Access Compliance Report

Public Rights-of-Way

(Pedestrian Signals)

Intersection ID: N/A	Main Street:	Cross Street: N/A	Location: N/A
ADA ID: 96F4E999BEF6	Signal Type: One Push Button-APS	Overall Compliance: No	Severity Score: BTN 1: N/A BTN 2: N/A No BTN: N/A
Codes/Mitigation Info/Possible Solution		Field Measurements/Component Compliance

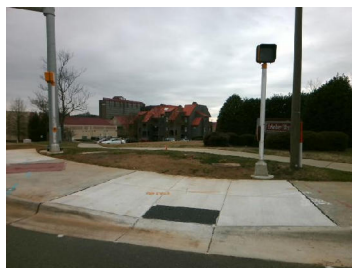
Surveyor Notes: NOT HOOKED UP, NOISES AND VERBAL COMMANDS UNKNOWN

PROW/ADA: TMUTCD 4e.08, R404.2, R404.7.2, MUTCD 4e.08, R104.2, R209.1,

Possible Solutions: Replace Signal Push Button With APS Button on New Post. Remove & Relocate Sign.
